## STAFF RECOMMENDATION 907 S Douglas Avenue March 20, 2019

**Application:** New Construction--Addition; Setback Determination  
**District:** Waverly-Belmont Neighborhood Conservation Zoning Overlay  
**Council District:** 07  
**Base Zoning:** R-8  
**Map and Parcel Number:** 10514001000  
**Applicant:** Michael Ward  
**Project Lead:** Jenny Warren, jenny.warren@nashville.gov

**Description of Project:** Application for the new construction of an addition which steps wider than the historic house and includes an attached garage. A setback determination is needed for the garage, facing the side alley.

Figure 5: Front elevation with proposed wider portion of addition showing on the left.

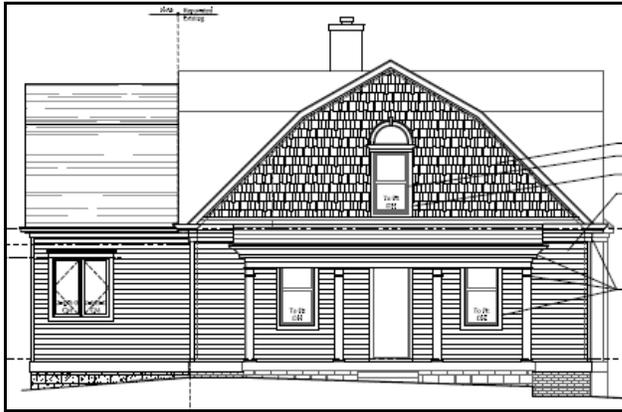
The proposed addition will be wider than the historic house by approximately thirteen feet (13') on the left side. (See Figure 5.) The property is shifted on the sixty foot (60') wide lot and meets the requirements of the guidelines for a wider addition, with a two foot (2') deep inset provided for a length of four feet (4'). The wider portion will be thirty-four feet (34') back from the front wall of the historic house and will be one foot (1') shorter, with a side-gambrel roof form.

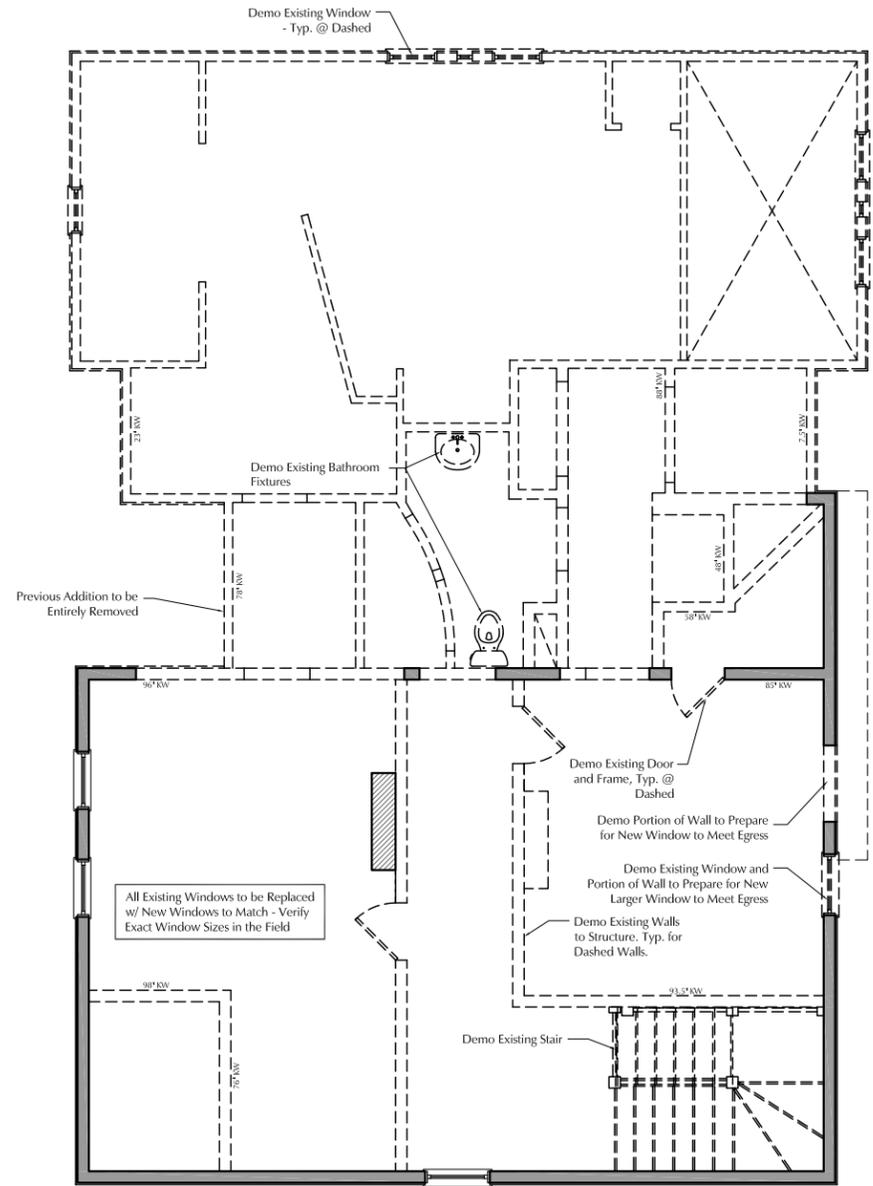
Outbuildings: The addition includes a proposed side-loading attached garage. Attached garages are typically not considered appropriate in conservation overlays. In this instance, staff finds that an attached garage could be appropriate for several reasons. The lot is oddly shaped with a side property line depth of only one-hundred-and-twelve feet (112') along the alley, making the buildable space behind the historic house limited. The rear sewer easement further limits the buildable space by making the last twenty feet (20') of the property – where an outbuilding would typically be located – unbuildable. The sewer easement and the lack of a rear alley also require that the garage be side-loaded from the alley rather than the typical rear-loaded garage. Due to this combination of site restraints, staff finds the proposed side-loading attached garage appropriate in this specific situation.

Staff finds that the project meets section III.H. of the design guidelines for outbuildings.

1 Southwest Elevation  
 Scale: 1/8"=1'-0"

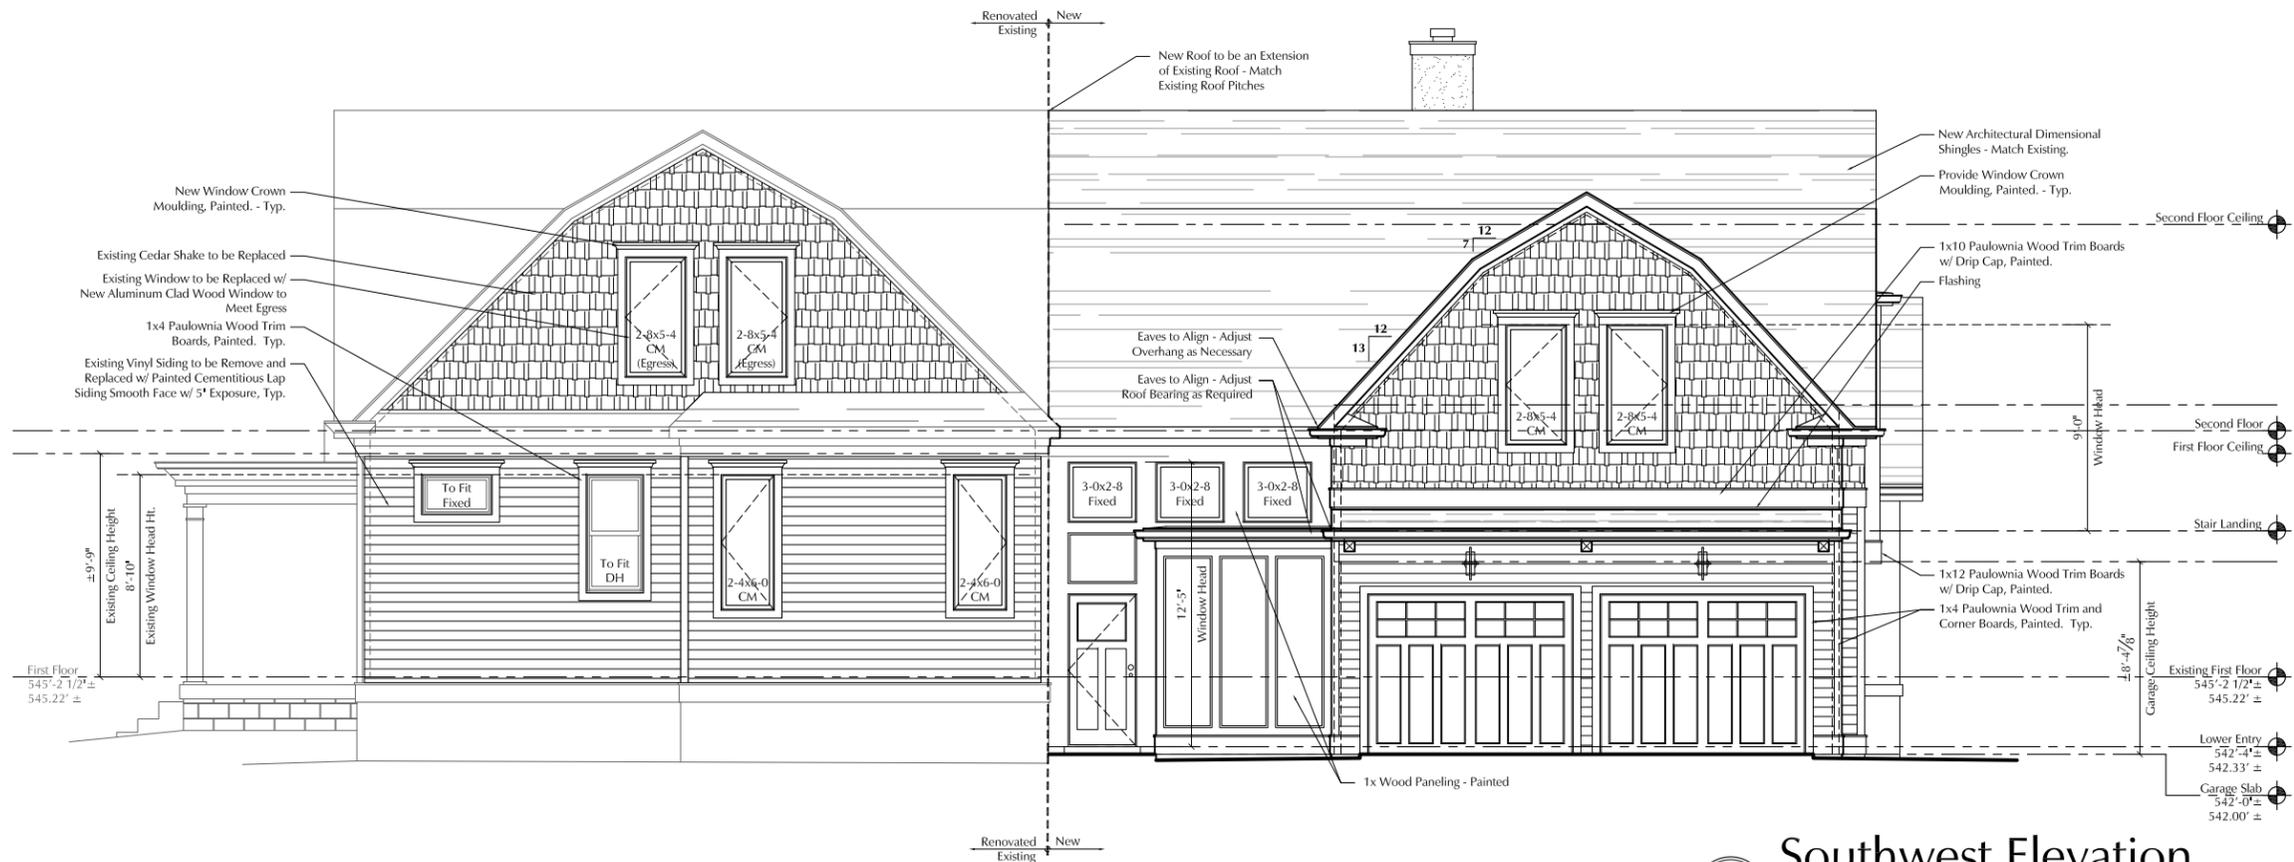
Proportion and Rhythm of Openings: The windows on the proposed addition are all generally twice as tall as they are wide, thereby meeting the historic proportions of openings. The one exception are the small windows surrounding the door on the recessed portion of the southwest elevation. These windows read as transoms and are in a recessed portion of the addition; staff finds them to be appropriate. There are also two small squared windows on the rear elevation, but due to their location, staff finds these appropriate as well. There are no large expanses of wall space without a window or door opening.
